Re: Stowe Mountain Resort Big Spruce Brook 1272 Order

**STOWE MOUNTAIN RESORT
IRON SEEP REMEDIATION PLAN
GOLF COURSE CLUBHOUSE VICINITY**

Re: Stowe Mountain Resort Big Spruce Brook 1272 Order:

Stowe Mountain Resort
Proposed Iron Seep Remediation Plan
Golf Course Clubhouse Vicinity

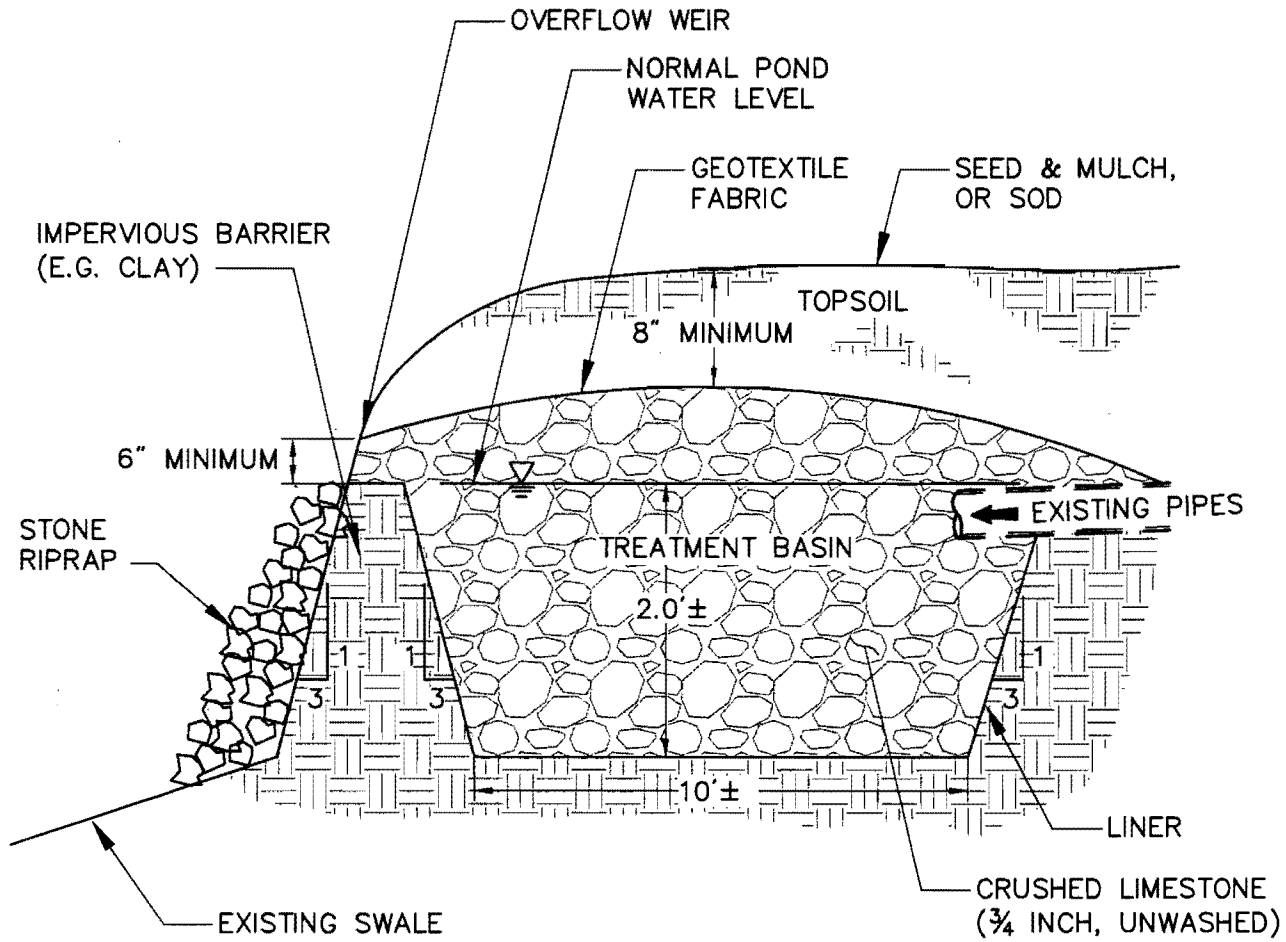
1. Addressing the groundwater iron seep using the proposed remediation plan as presented in VHB Pioneer's Stowe Mountain Resort Iron Seep Remediation Plan Golf Course Clubhouse Vicinity is acceptable as proposed. However, we request that the weekly post-construction visual observations be submitted to us electronically as a quarterly summary.

**OVERALL
 STORM DRAIN
 REALIGNMENT
 SITE PLAN**

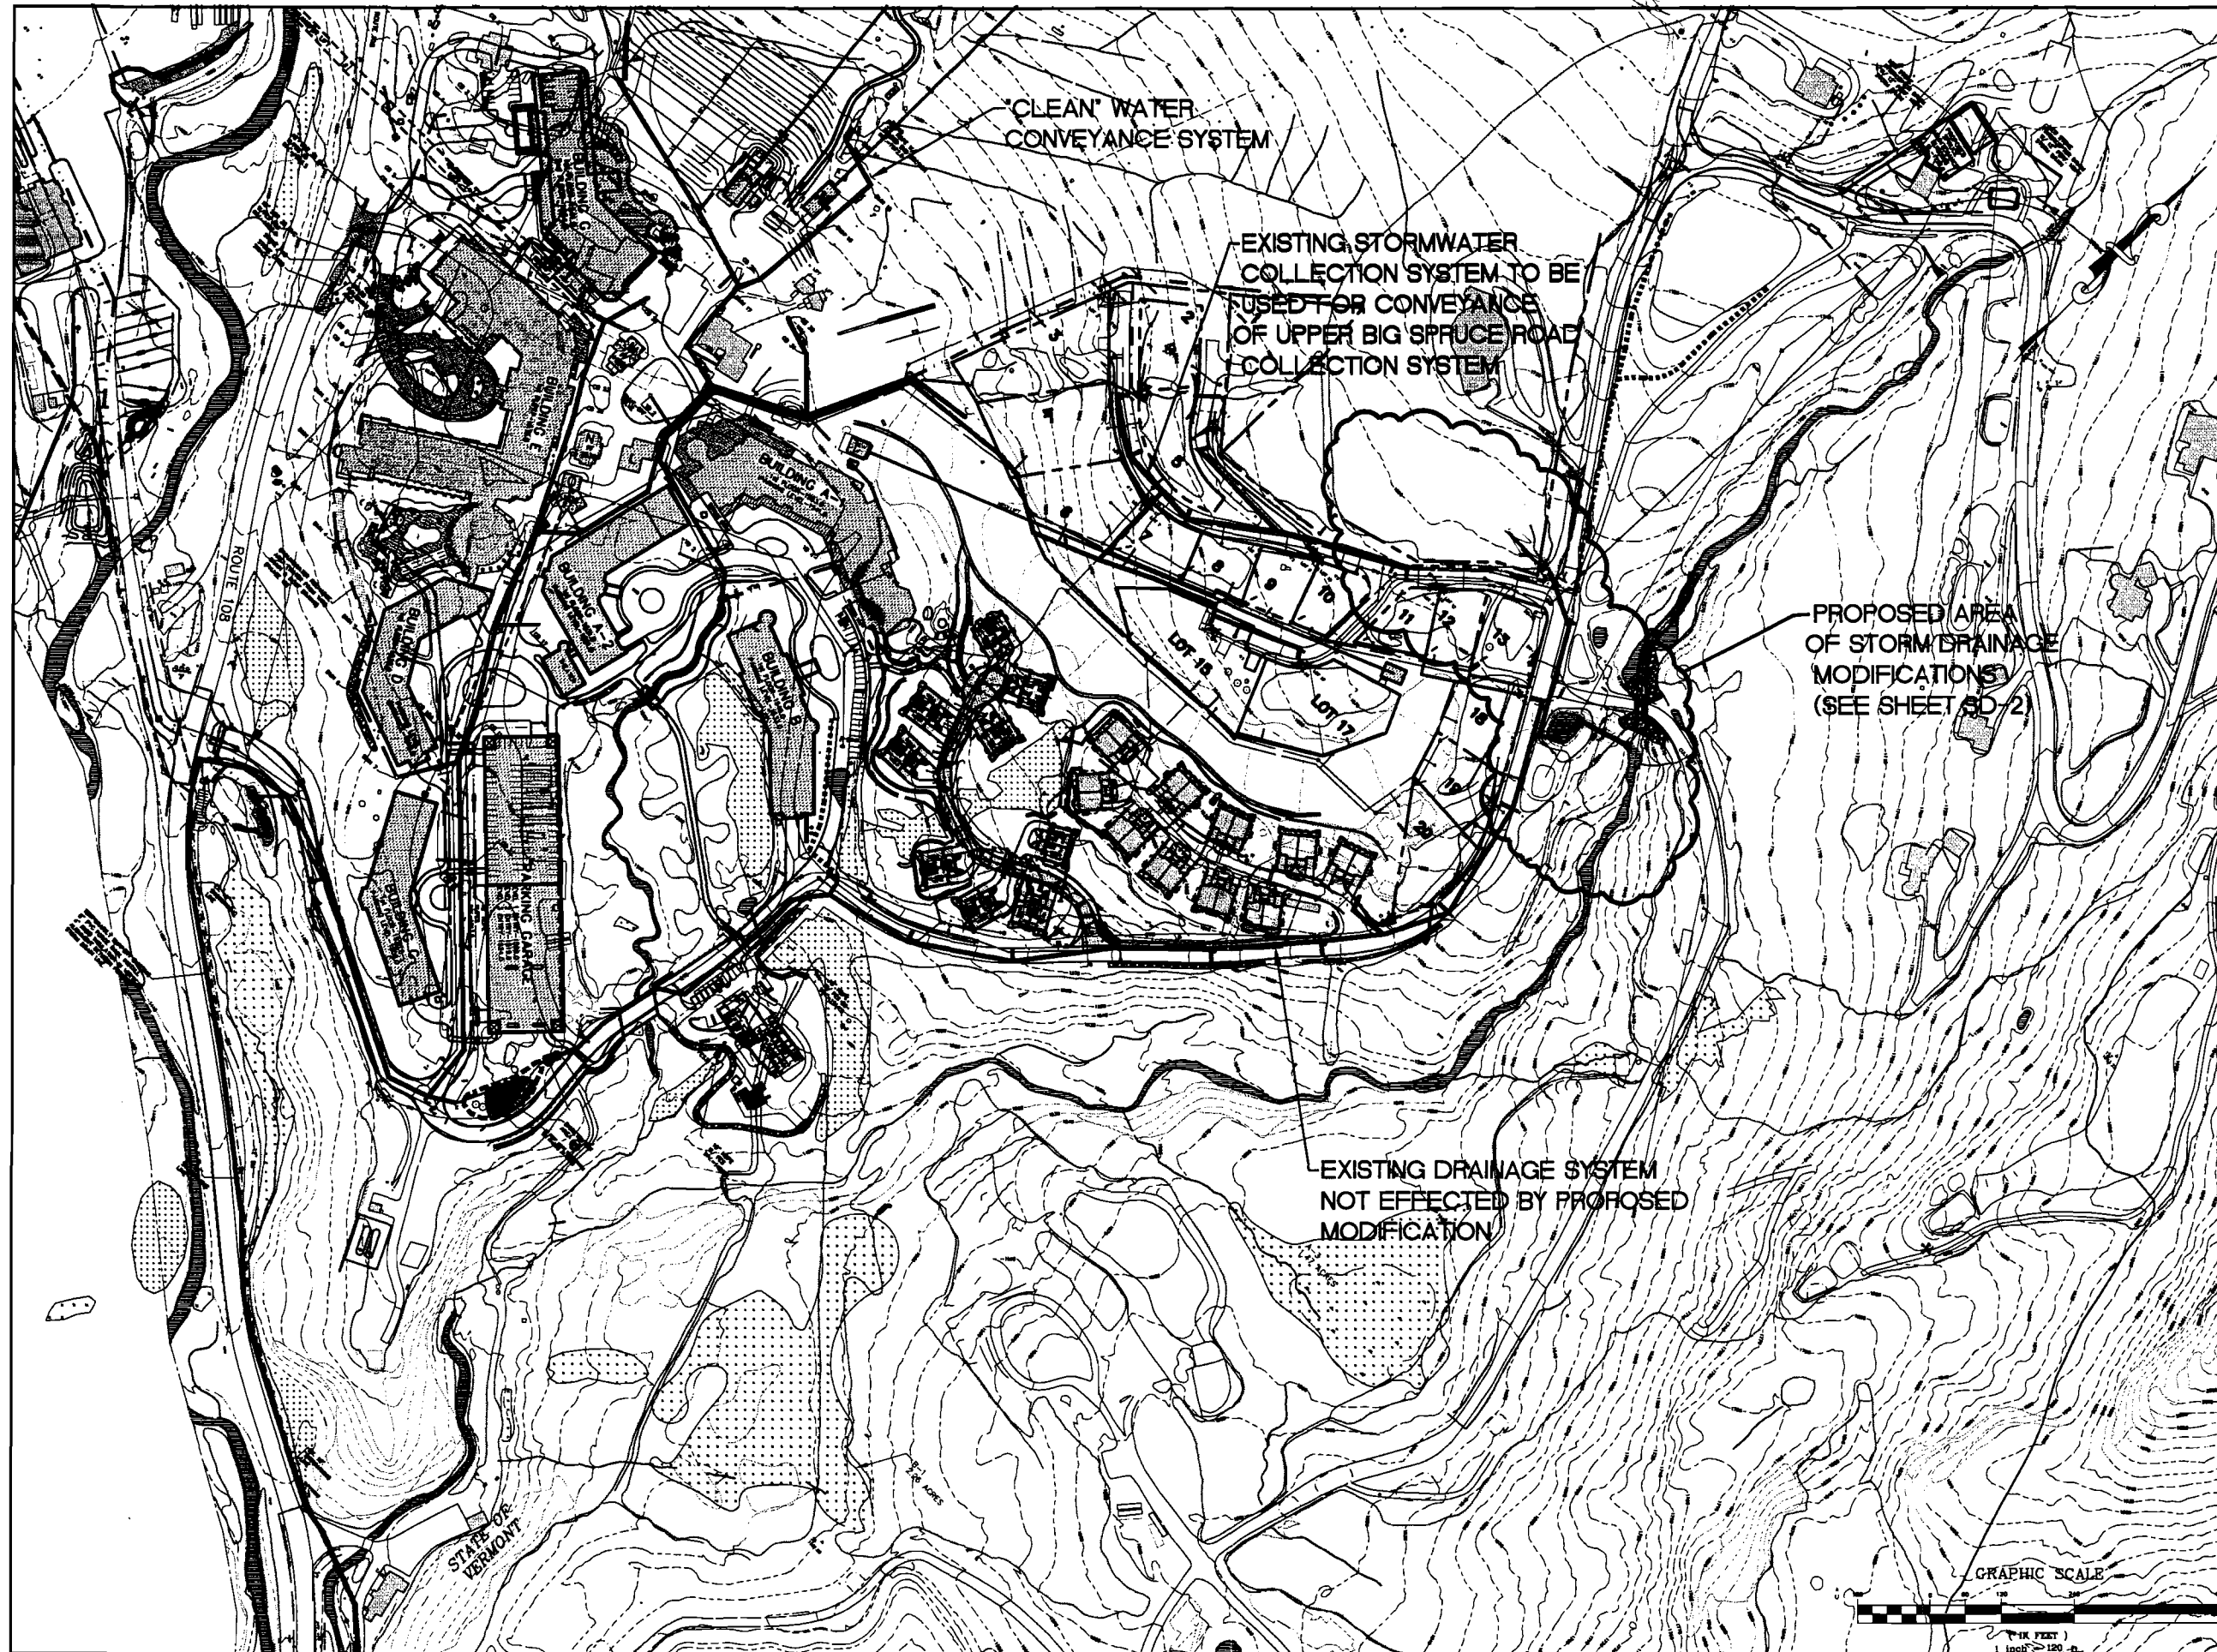
3. We request that the proposed plan to lower the impacts of sediment into Big Spruce Brook be amended to include the following components:
 - a) Stormwater runoff from Big Spruce Road should be collected on both sides of the road before being collected at National Drive. Currently only the east side of road is being collected and treated. The runoff from the west side of the road discharges to the brook that runs alongside the roadway without sufficient treatment. A roadside ditch with a permanent check dam system, or stone lined waterway, designed according to the Vermont Standards and Specifications for Erosion Prevention and Sediment Control should be included for both sides of the road.

- b) Please evaluate whether the Spruce Hamlet stormwater collection and treatment system can accommodate the additional flows within the permitted design capacity.

- c) The culvert that crosses under the driveway to the Ski Club should be eliminated to avoid co-mingling of roadway runoff and the stream.
